References: (1) Enrico Fermi Atomic Power Plant, Unit 2
NRC Docket No. 50-341
(2) EF2-54,761 dated August 25, 1981
(3) EF2-54,665 dated September 9, 1981

Subject: Seismic Re-Evaluation of the NSSS Piping

Current SER Discussion

Detroit Edison Comments

SECONDARY CONTAINMENT RESPONSE
DUE TO A DBA-LOCA

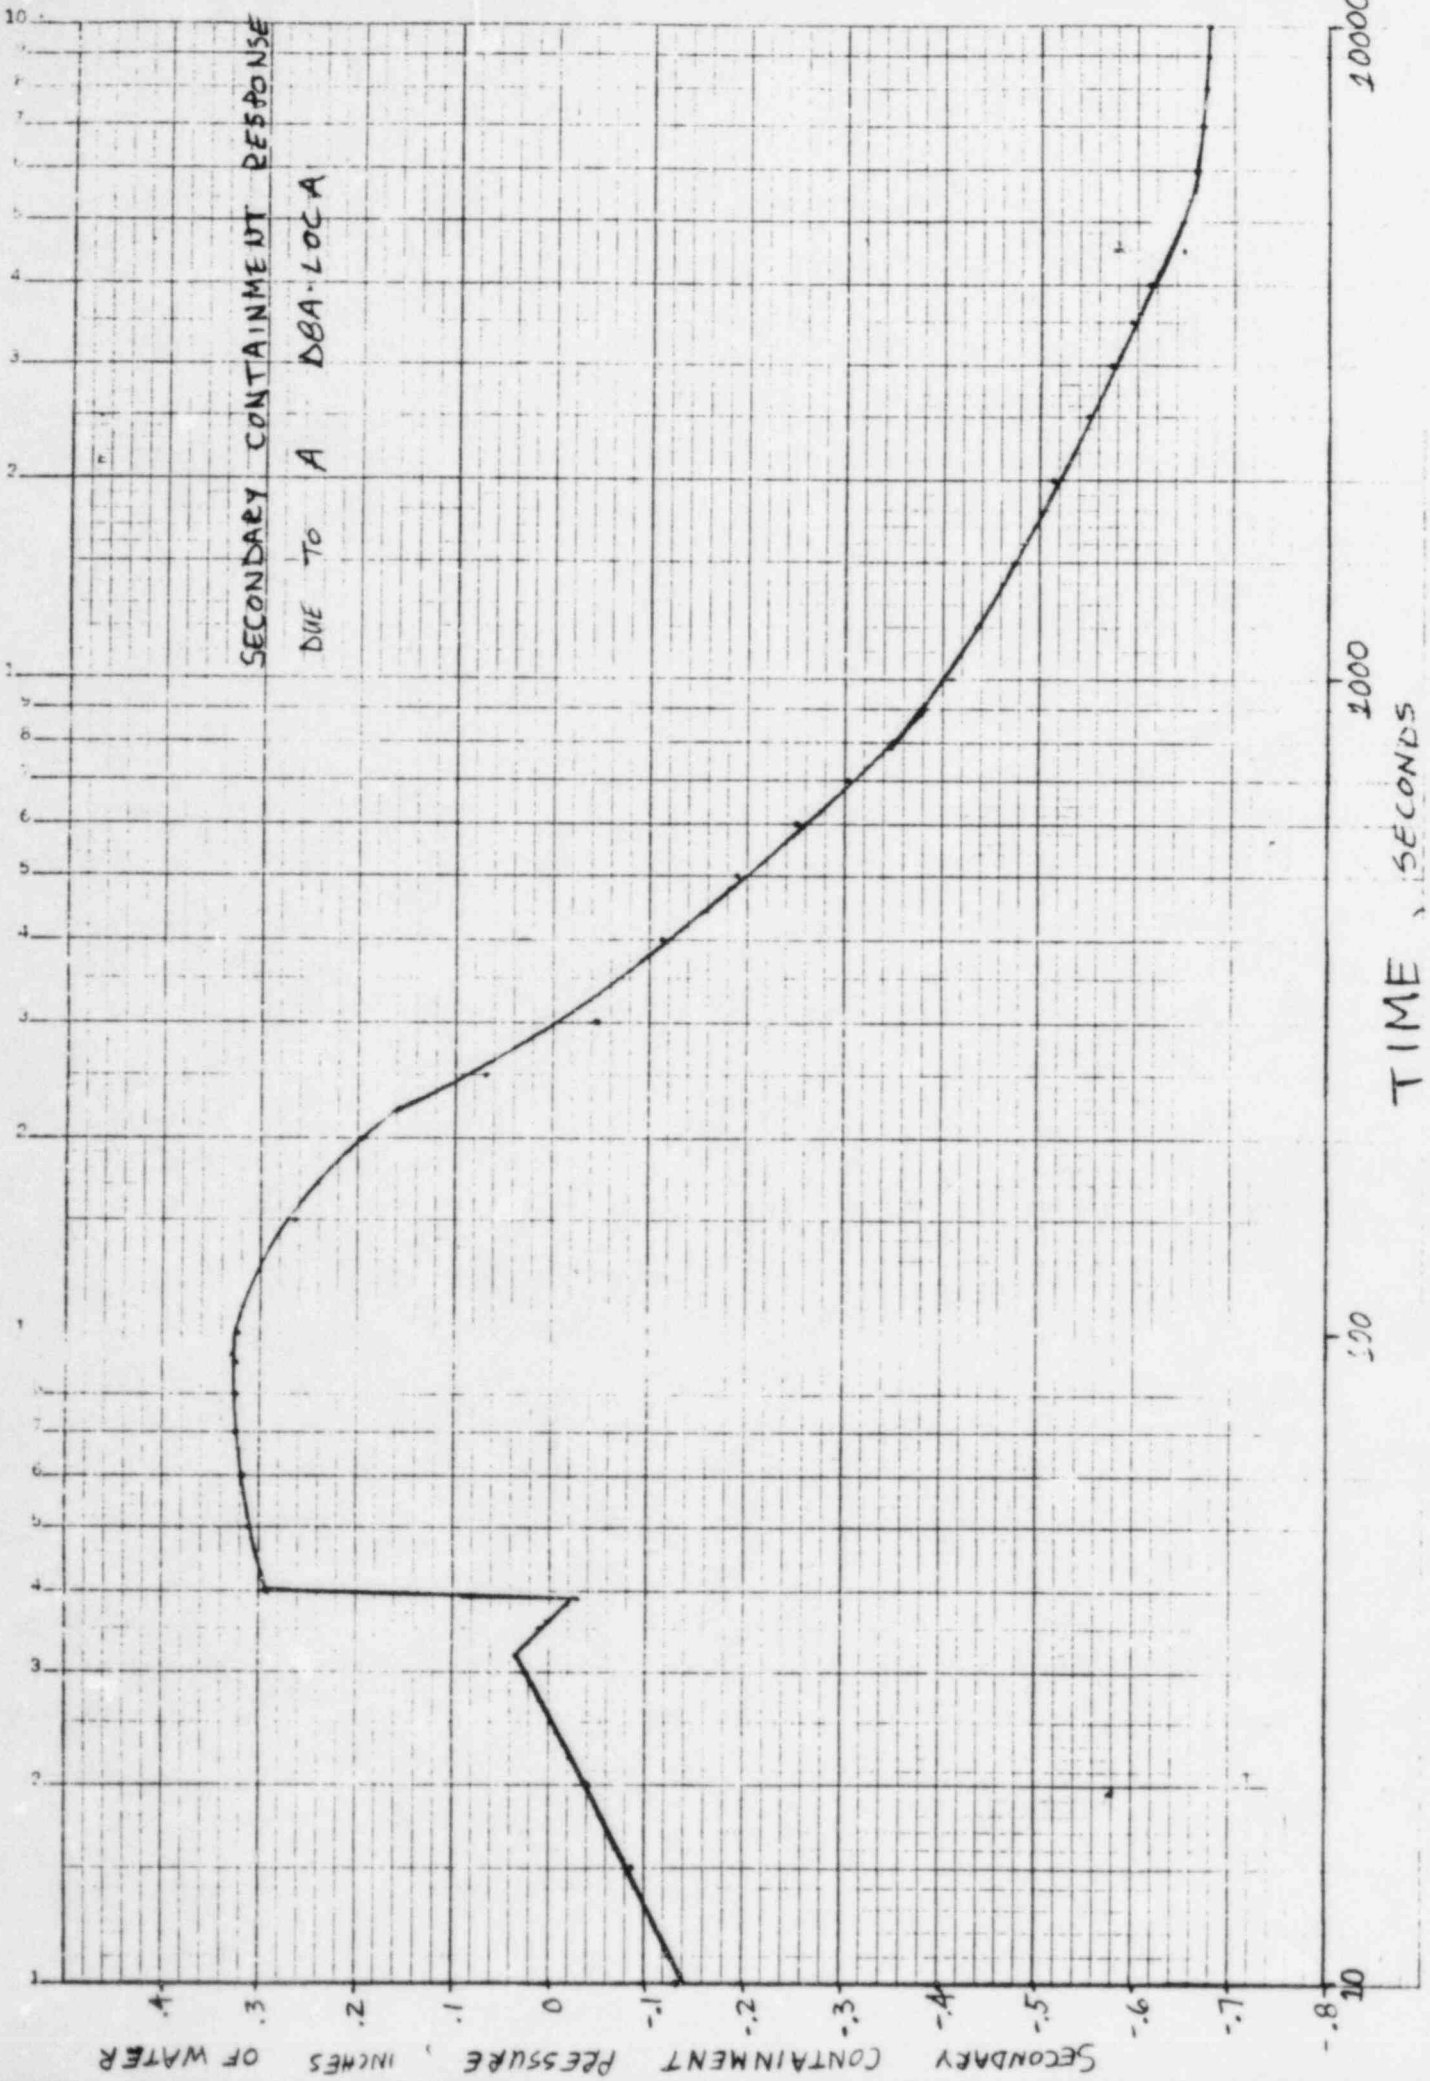
The secondary containment response due to a DBA-LOCA is shown in Figure 1. During the first 33 seconds, the pressure increases to a slightly positive value. With the activation of the SGTS at 33 seconds and the activation of the area coolers at 38 seconds, the pressure decreases to near atmospheric.

At 40 seconds, pressure relieving doors on the common wall between the torus room and the corner rooms open and allow heated torus room air to enter the rest of secondary containment. This step input of heat into the secondary containment appears as a sharp pressure spike on Figure 1.

The pressure then decreases past -0.25 inches of water to a steady state secondary containment pressure. A period of approximately 600 seconds elapses from the start of the DBA-LOCA event to the point where the secondary containment pressure decreases to and subsequently stays below -0.25 inches of water.
